Work Order ID 154484

Item ID: D5162-041 Accept *N900040100* Setup Start *NS1*
 Revision ID: Stop *NS2*
 Item Name: Seat Structure Assembly
 Start Date: 1/9/2017 Start Qty: 1.00 *1* Cust Item ID:
 Required Date: 1/16/2017 Req'd Qty: 1.00 *1* Customer:
 Reference:

DRAWING NO. D3016	TITLE SEAT FRAME ASSEMBLY	REV. A	DART AEROSPACE LTD ENGINEERING ORDER	D.E.O. NO. D3016-A-1	SHEET NO. SHEET 1 OF 1	SCALE NTS
DRAWN 1	CHECKED UP	MFG. APPR. RE	APPROVED WAP	DE APPR. W		
DATE 10.01.29	DATE 10.01.29	DATE 10.01.29	DATE 10.01.29	DATE 10.01.29

D3016-11 SADDLE

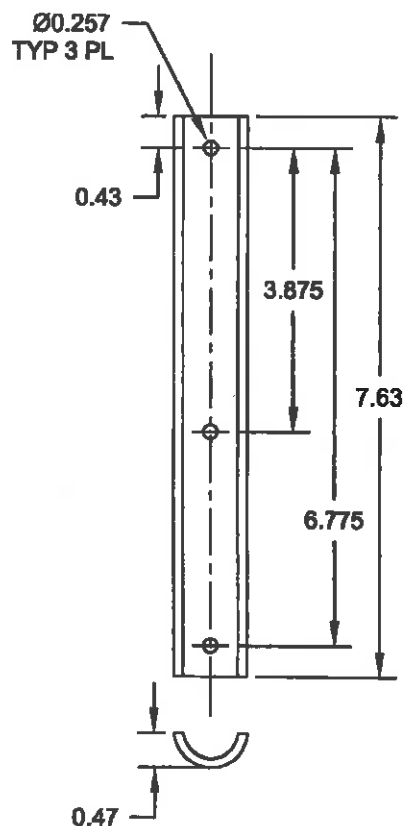
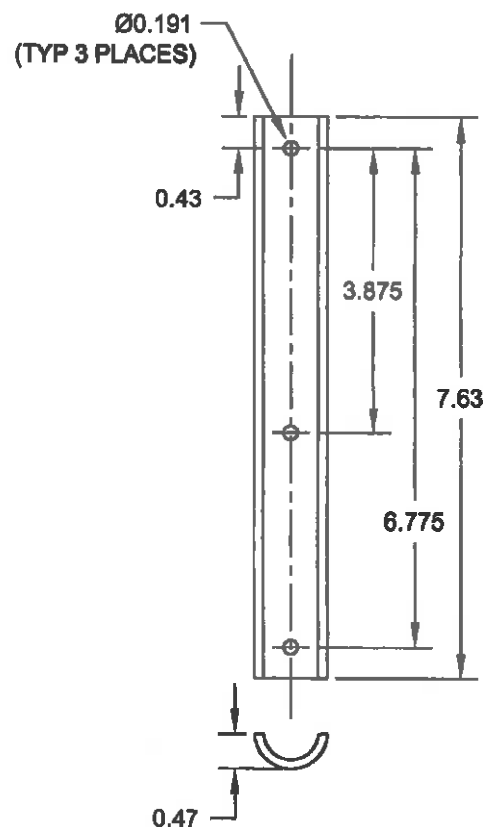
TO REVISE D3016-11 SADDLE'S HOLE SIZES

DETAIL D3016-11 SADDLE (SHEET 3): Ø0.257 TYP 3 PL WAS Ø0.191 (TYP 3 PLACES) AS SHOWN:
